TECHNICAL INFORMATION COMMUNICATION

Number: TIC2021-0004

Title: Modulating Inducer Assembly Power Connector Plug Position

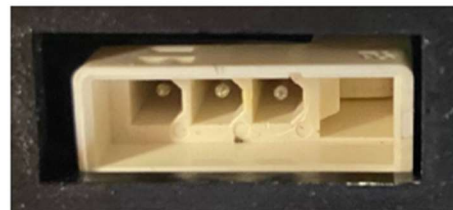
Investigation of modulating inducer assemblies that had been returned for noise has identified a potential for the power connector inside the assembly housing to be pushed under the edge of the assembly which could interfere with proper harness connection. This interference results in a potential of noisy or no operation of the inducer motor.

It is believed this incorrect position may be a result of movement during shipping or unit handling and not typical of operational movement.

1. In the event of inducer operational noise or no run condition review the position of the motor power connector. If the connector is out of position partially under the housing edge as shown in picture above (B) the connector position can be corrected in the field.
 - a. Disconnect from the incorrectly positioned connector and manually manipulate the connector out from under the edge of the housing to represent the correct position shown above (A). Reconnect the connector and verify proper operation.

1. Redesign of the motor power connector mold will prevent the connector from being able to move under the housing edge and interfering with the harness connection. This will be a running change and seamless to the field.
